April 23, 2019

Version 2

2018 Accord: Rear Tray Rattles

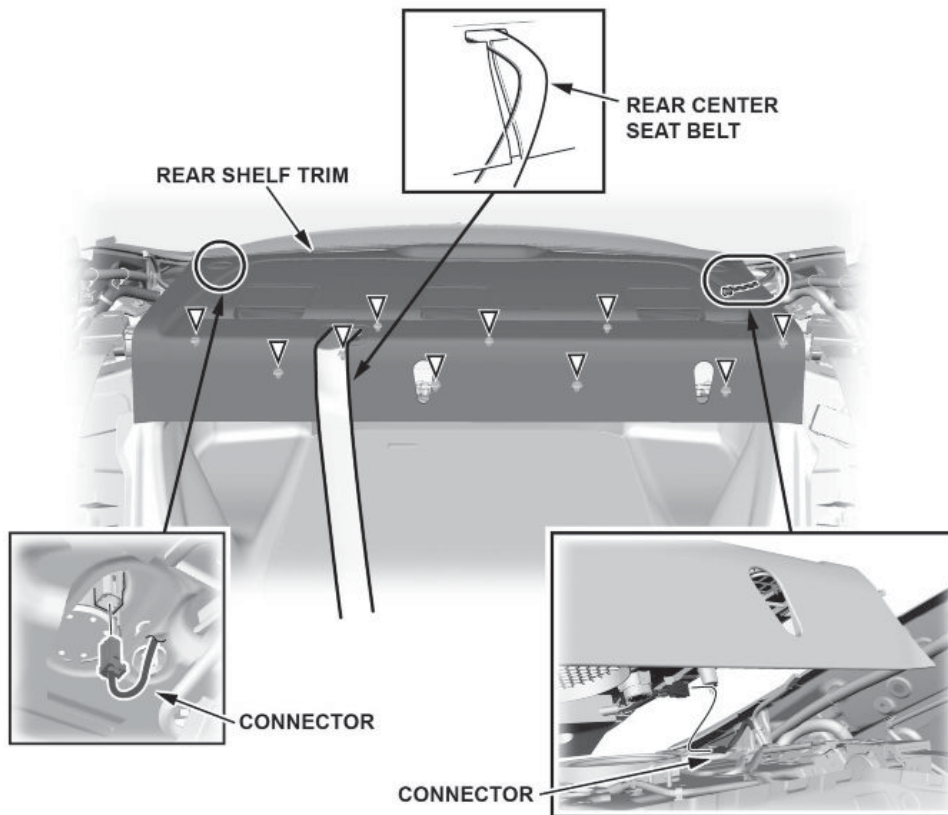
The rear tray may be warped in the back corners.

Apply a **5 mm X 50 mm** piece of EPT foam to each back corner of the rear tray.

7. Cut two pieces of EPT foam **5 mm X 50 mm**.

8. Clean the surface of the rear shelf where the EPT foam will attach. Then, apply the cut pieces of EPT Foam to each corner of the rear shelf as shown.
9. Install all removed parts in the reverse order of removal.
10. Make sure the noise is gone.
